RE: DOCKET NO. 030-05222 - AMENDMENT TO RADIOACTIVE MATERIAL LICENSE NO. 29-00139-02

ADDENDUM TO:
**A RADIOLOGICAL DECOMMISSIONING PLAN FOR RADIODIAGNOSTIC
MANUFACTURING FACILITY AND ASSOCIATED EQUIPMENT**
FOR
CHARACTERIZATION AND REMEDIATION OF IMPACTED SOIL

E. R. SQUIBB & SONS,
a wholly owned subsidiary of
BRISTOL-MYERS SQUIBB COMPANY

NRC License No. 29-00139-02
New Jersey State License No. 10071
NEW BRUNSWICK, NEW JERSEY

Figure 1 : Initial Sample Locations

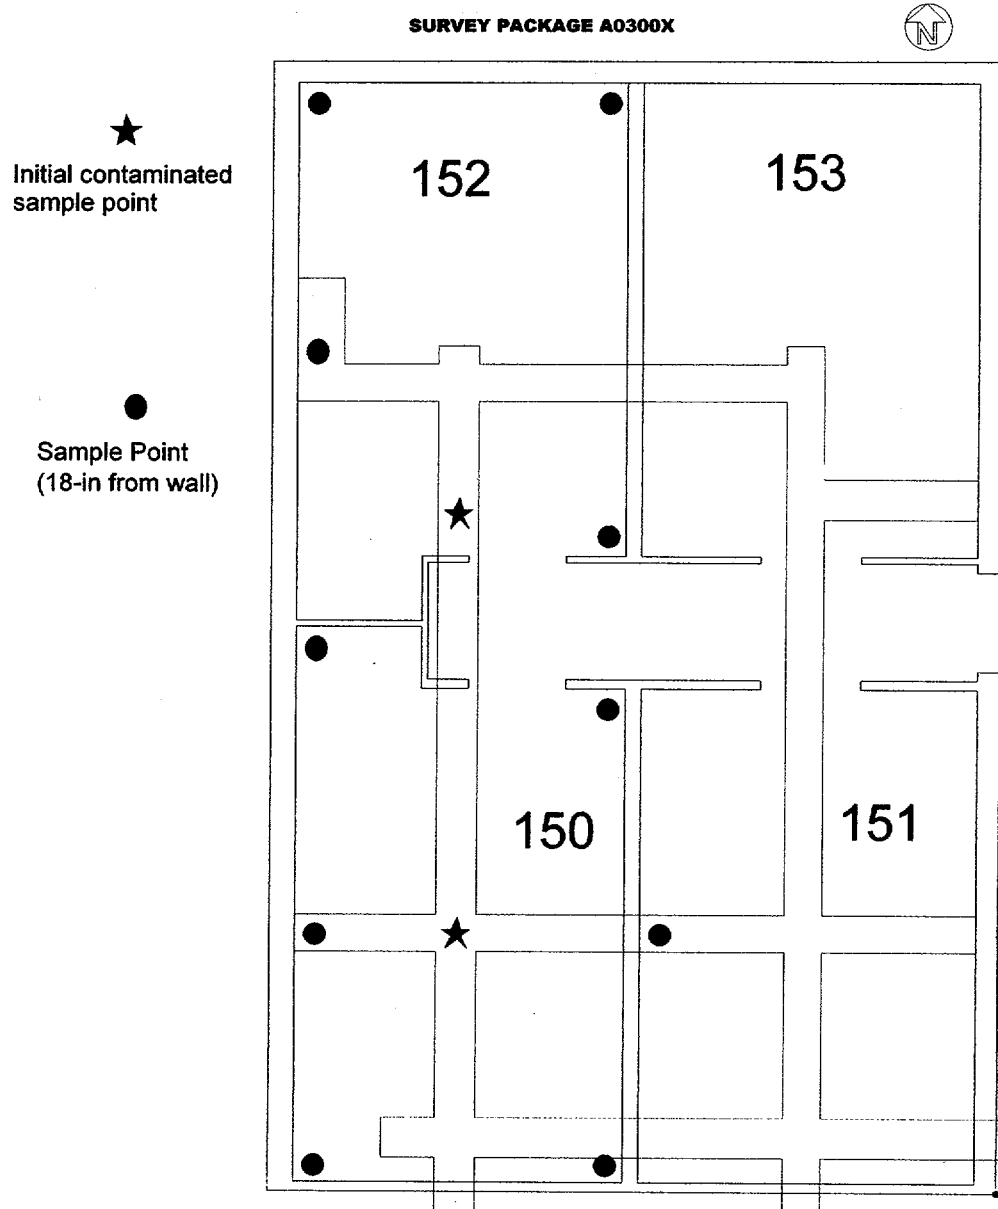
The initial samples will be taken at approximately 18-inches from room walls at the locations shown in Figure 1. These samples will be taken at incremental depths up to four feet below the soil surface. These samples will be analyzed onsite and if all these samples are clean then additional samples will be taken further from the walls to determine the extent of the contamination. If the samples are contaminated, additional samples will be taken at a greater distance from the trenches to determine the outer boundaries or extent of the contamination.
